From: [REDACTED]
Sent: Thursday, June 3, 2021 3:57 PM
To: Ann Ritzma; Al Royse; Christine Kroluk; Marie Chuang; Sophie Cole; Larry May
Cc: Wireless Comments; Christopher Diaz; Lisa Natusch
Subject: PLEASE READ - Public comment for special meeting of Town Council on 6/3/21 regarding cell tower applications

I am writing in opposition of the 8 proposed monopoles under applications H05M2, H07M2, H08M2, H19M3, H20M3, H21M3, H28M3, H31M2. They are in violation of the equipment volume and cabinet standards as defined in the wireless design standards policy 19-01 and should be denied.

Figure 1: PGE SmartPole Meter located in Radom:

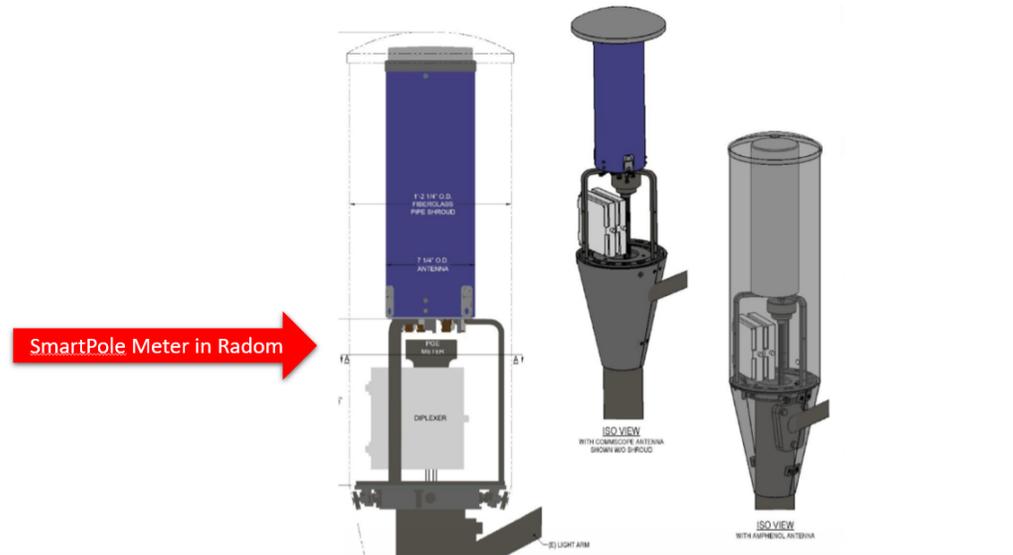
During the 6/1 hearing I pointed out that PGE’s Greenbook Utility Bulletin: TD-027911-B004 dated 11/15/19 lays out PGE’s preferred requirements for “SmartPole Meters” to be integrated in monopoles.

This reference design should be applied to the proposed replacement tower at **H07M2** which has a streetlight and conforms to the requirements in this bulletin.

Crown Castle is trying to avoid co-locating the meter and disconnect in their enclosure so that they don’t have to coordinate with PGE to complete the install or perform maintenance. This request for an exception is opportunistic and is not a technical requirement. Other municipalities also require meter and disconnects to be included in their monopole designs. The Town cannot solely rely on Crown Castle’s assertion that the “only” solution requires a separate equipment cabinet for PGE. I ask that Town Staff contact the following engineering resources at PGE to confirm that the SmartPole Meter may be used on monopoles that don’t have streetlights.
